In reply refer to:
P-1175-WV
London-Marmet Project

Re: Marmet Development – 100% Design for Sheet Pile Bulkhead Repair

This is in regard to your submittal under cover letter dated October 19, 2023, which provided the 100% design documents for the repair of the Marmet Development sheet pile abutment, which is part of the London-Marmet Project, FERC Project No. 1175-WV.

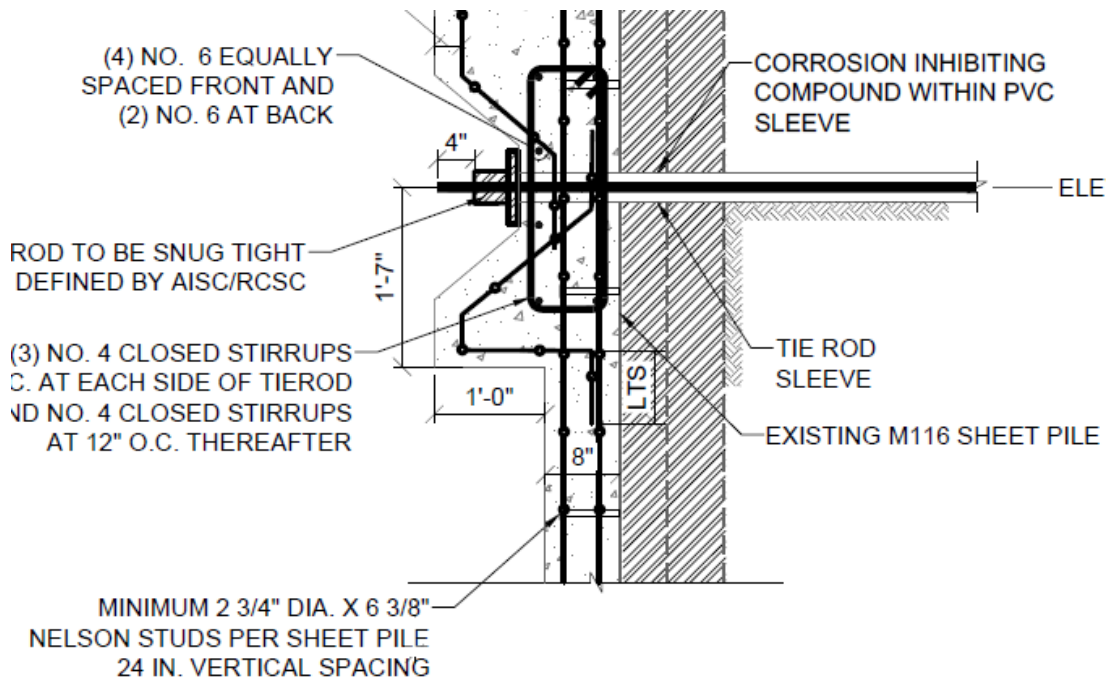
5. Provide a schedule for the tieback anchors that includes pertinent elevations, stressing lengths, bond lengths and design loads.
6. The reinforcement and wire mesh shown in Details C and D on Drawing S-011 appear very congested and may not provide enough space to ensure that the concrete can be properly consolidated (see figure below). Please review and revise as needed.
